Well Name: EMSU-B	Well Location: T20S / R36E / SEC 24 / NESW / 32.5568372 / -103.3100659	County or Parish/State: LEA / NM
Well Number: 912	Type of Well: INJECTION - ENHANCED RECOVERY	Allottee or Tribe Name:
Lease Number: NMLC030143B	Unit or CA Name: EUNICE MONUMENT SOUTH UNIT	Unit or CA Number: NMNM70948B
US Well Number: 300250430500S1	Operator: EMPIRE NEW MEXICO LLC

Notice of Intent

Type of Submission: Notice of Intent	Type of Action: Plug and Abandonment
Date Sundry Submitted: 06/27/2024	Time Sundry Submitted: 08:31
Date proposed operation will begin: 08/01/2024

Proposed WBD

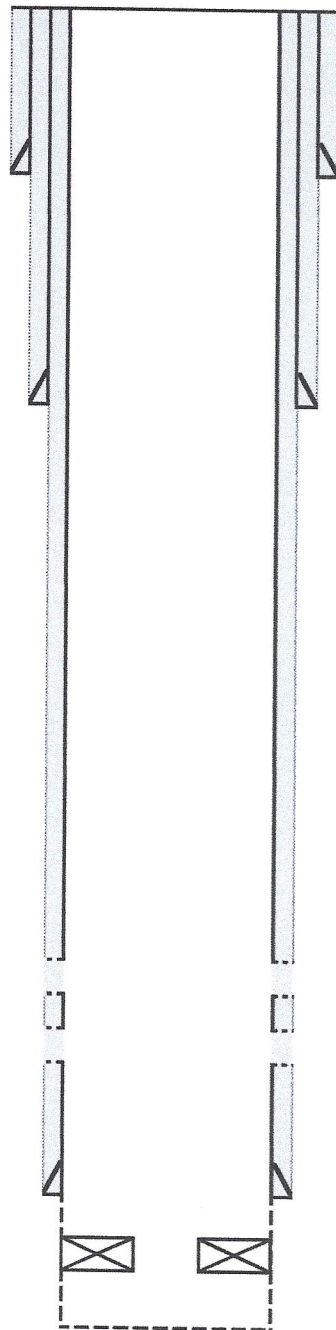
27 2668' to 2454'

Spot ~~25~~ sks Class C cmt @ ~~2580' - 2320'~~ (B/Salt), WOC & tag.

Spot 76 sks

Leak test CIBP. WOC & TAG. @ 3112'

* Run CBL from CIBP to surface.

5.5 inch- Shoe Plug	3676.36	3814.00	137.64	Tag/Verify			
				If solid base no need to Tag (CIBP present and/or Mechanical Integrity Test), If Perf & Sqz then Tag, Leak Test all CIBP if no Open Perforations			
CIBP Plug	3679.00	3714.00	35.00		76.00	C	Set CIBP at 3714'. Leak test CIBP. Spot cement from 3714' to 3112'. WOC and Tag.
